PCN #: 2585

PCN Title: Qualified Additional Assembly/Test (A/T) Sites, Wafer Fab Backend  
IMD Material and Process, and Package Outline Dimension Change

**PRODUCT CHANGE NOTICE****PCN-2585 REV 1**

Table A

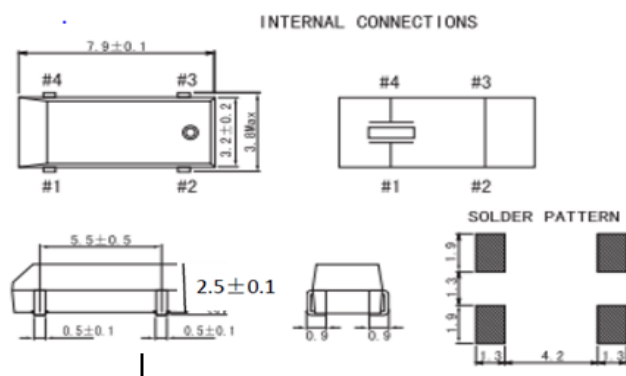
**Table 4 - POD Change from 2.5+-0.1mm to 2.4+-0.1mm (See Table A)**

|                      | Current    | New        |
|----------------------|------------|------------|
| Total Package Height | 2.5+-0.1mm | 2.4+-0.1mm |

Current G4 TYPE height spec

New G4 TYPE height spec
